1228 5th Ave N

Recommendation Meeting · May 20, 2015
DPD Project #3016985

b9 architects

BOARD RECOMMENDATION

1 View looking south east on 5th Avenue N

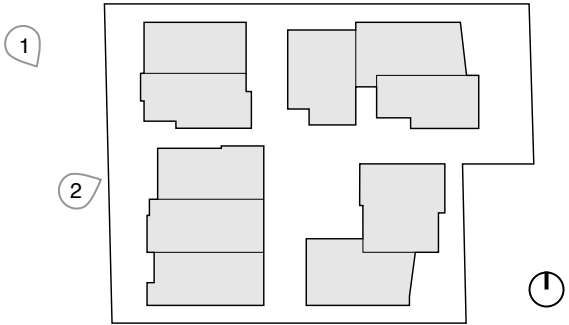
6. The modulation suggested at the parapet level, differentiating individual townhouse units, was considered a positive feature in the early design, but the Board would like to see a further investigation of what might be the benefits of stepping down the ground floor plates of the individual units in response to the change in topography as the site stepped down from north to south, providing for even greater unit differentiation.

The comparison of the massing from EDG (shown above) to the current renderings, exhibits the change requested by the board in EDG item 6, to step roof lines down from north to south, following site topography and integrating more seamlessly into the neighborhood context.

Per the board's suggestion, roof lines of all units were modified and further modulated to step down from north to south, following the site's topography. This development from EDG is clearly seen in the comparison of the current facade with the massing at EDG, on a rendering in the following pages. The current roof line is seen in rendering 2 above. This modification helps integrate the project into the existing context of the neighborhood.

1 View from the Lower Courtyard looking west

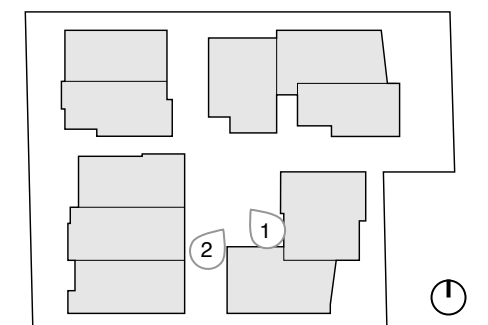
In EDG item 1, the board recommended an ample courtyard amenity space through the manipulation of each townhome on the site.

The renderings here and on the following pages exhibit the spacious outdoor courtyard at the center of the site, defined by the townhome units and their dynamic, multi-faceted and varied facades. The sculpting of each facade and the careful placement of each townhome on the site, results in an open space that enhances the site and responds directly to the board's suggestions.

1 View looking east from 5th Ave. N of Building 1 porches and central walkway

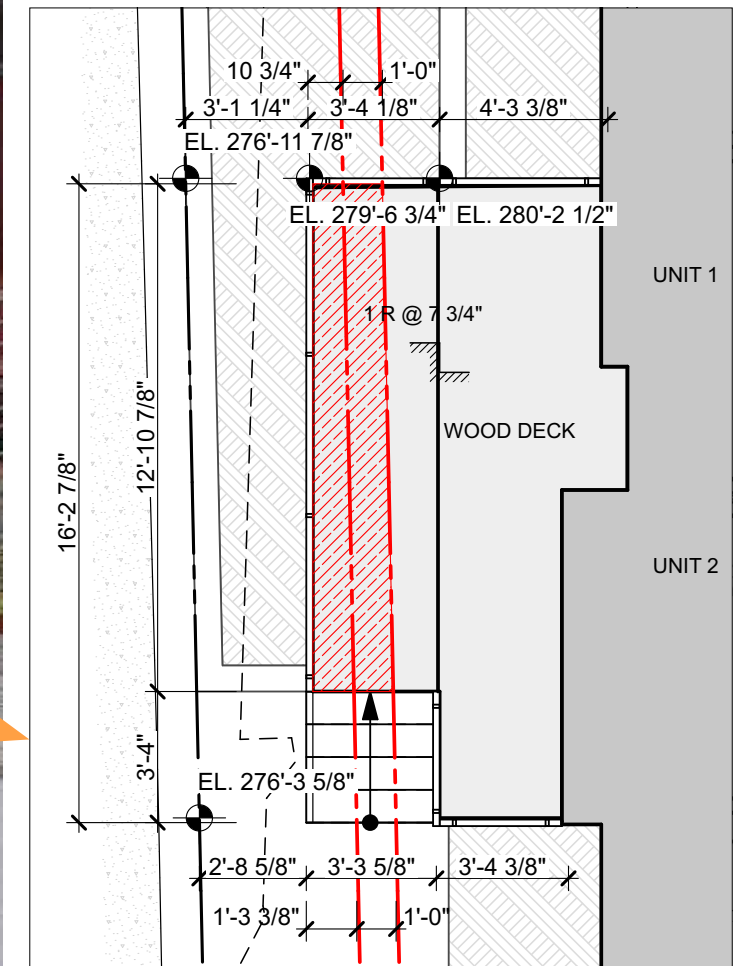
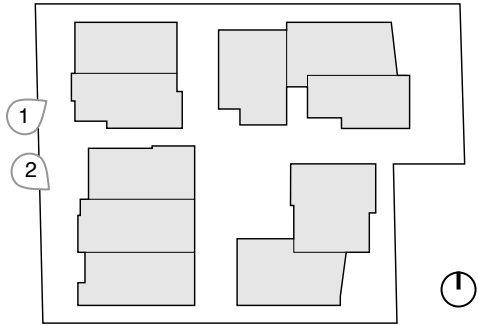
These renderings speak to the board's EDG item 7, requesting more detail at the shared porches fronting 5th Ave. N and a more robust landscape plan at this location.

The renderings exhibit how these porches would be detailed and activated, by its inhabitants and those passing by. Landscape shown and is representative of the landscape plan included in this packet. Departure requests are also shown in a diagram for clarification of the requests.

DEPARTURE REQUEST
3'-3 1/8" MAX. HEIGHT FOR A LENGTH OF
12'-10 7/8" WITHIN 4'-0" FROM PROPERTY LINE

DEPARTURE REQUEST
 6'-2 3/4" MAX. HEIGHT FOR A LENGTH OF 6'-6 1/4" WITHIN 4'-0" FROM PROPERTY LINE

PRIVACY ELEVATION AT NORTH PROPERTY LINE

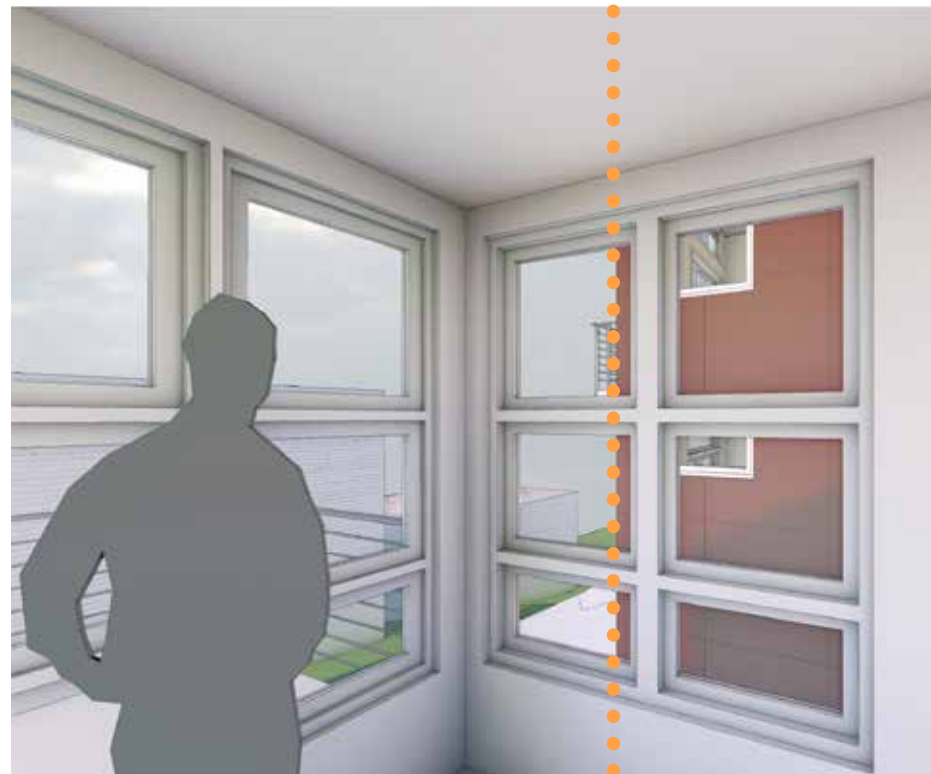
The board requested in EDG item 3 to provide detailed studies of the relationship between the proposed building and its neighbors, assuring privacy and comfort at all openings.

Blocking views for Union Vista condominiums to the north

The diagrams on this page and the following present those relationships and show that openings avoid direct alignment with neighboring buildings and privacy will be maintained throughout.

Through conversations with one of the northern neighbors, we reduced the facade length of unit 7 by nearly 5'-0" creating less loss of view for the Union Vista condominium. This loss of facade length resulted in an additional departure, supported by the neighbor, to have a less than 5'-0" setback from the property line for a portion of unit 7 where the wall position has no effect on the adjacent neighbor. The view to the lake and downtown was expressed as a clear priority.

VIEWS FROM 1216 TO THE SOUTH

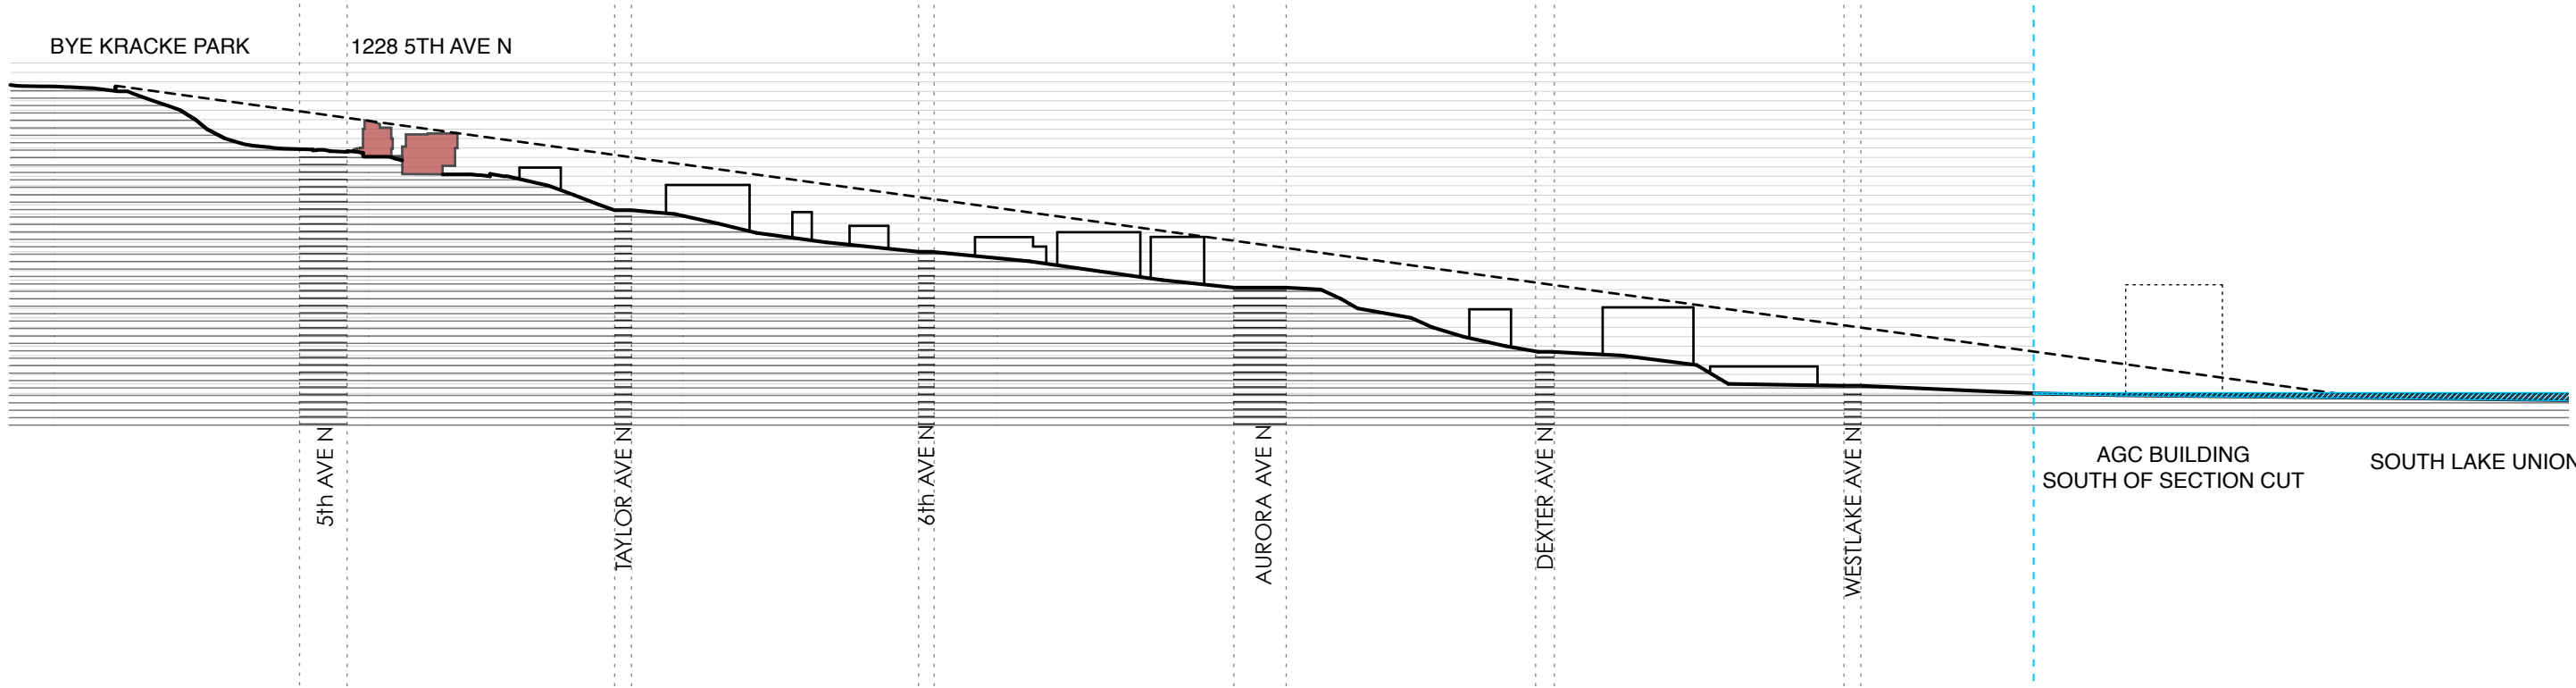
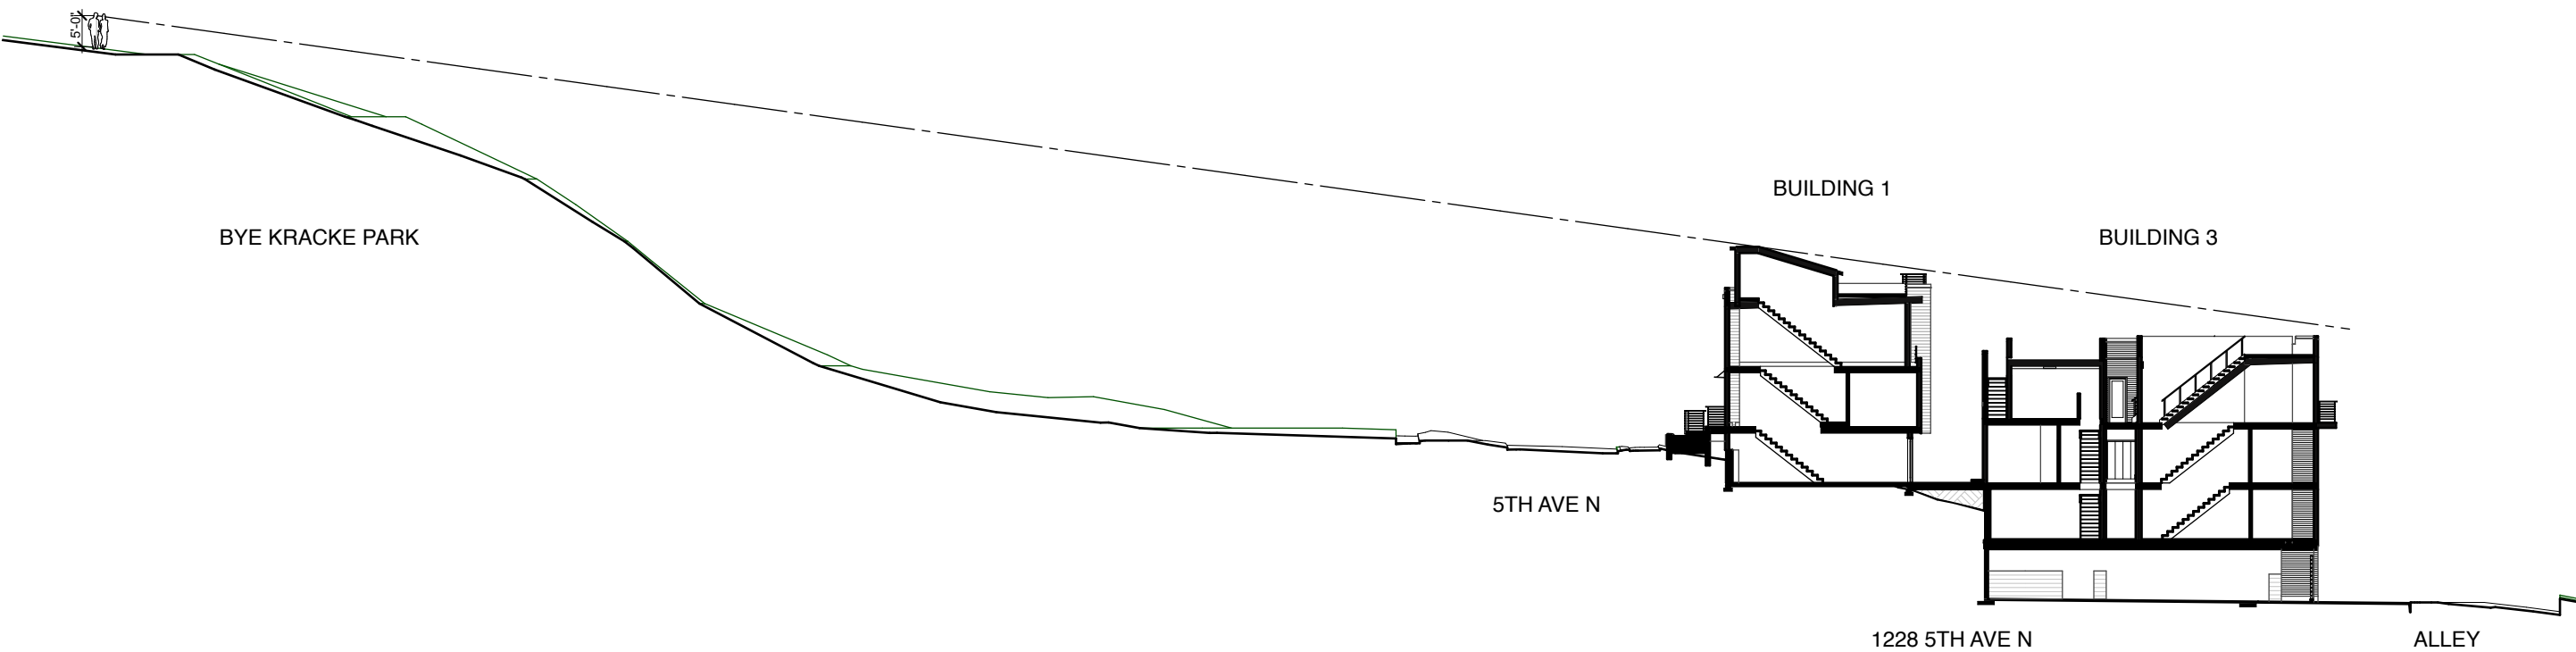
The neighbor to the south at 1216 5th Avenue N expressed concerns about the impacts of the placement of the color red outside her bedroom windows. Also expressed were concerns about privacy due to the deck projection to the east and the position of the kitchen window at unit 10.

The red paint was removed from the south facade of the building.

The size of the deck was reduced by nearly half its width so that the bedroom windows at 1216 would not be visible to someone standing on the deck.

The kitchen window was not reduced since its primary view is of the Seattle skyline.

View at MUP with higher roof elevations and alternative penthouse design

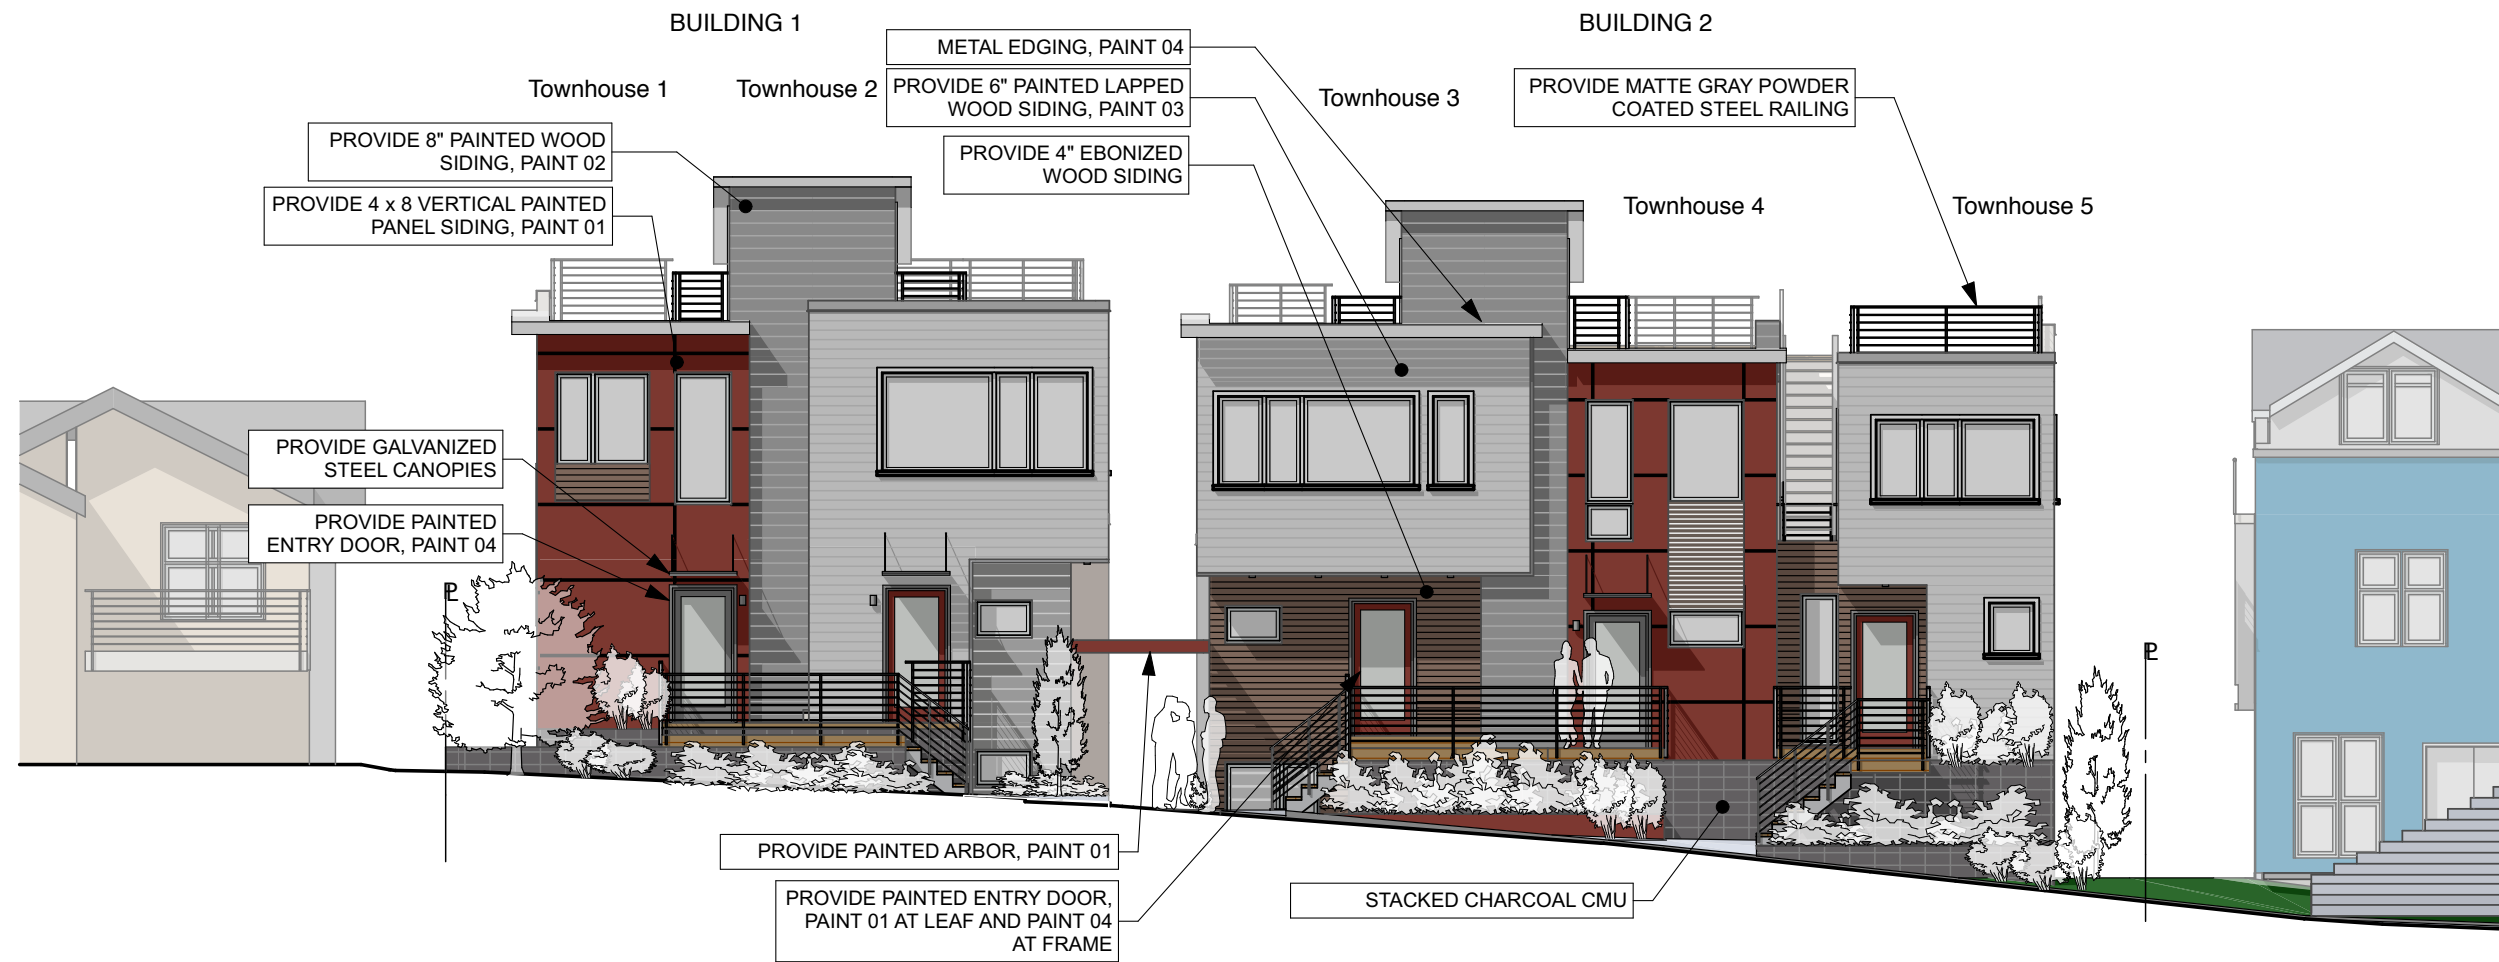
The board recommended creating a stronger connection between Bhy Kracke park and the proposed project, in EDG item 8.

This was achieved by reducing the overall height of buildings and by sloping the penthouse roofs down to the east, to protect the views from the park. Plants found in and around the park were also integrated in the landscape design for the project. Lastly, the central courtyard of the project intends to echo the role and uses of Bhy Kracke Park, and its value to the community. The central courtyard is similarly an open and flexible space; characterized by nature and the presence of diverse plants and trees; and provides an opportunity to share, be active, and enjoy space with others and encourage a sense of local community.
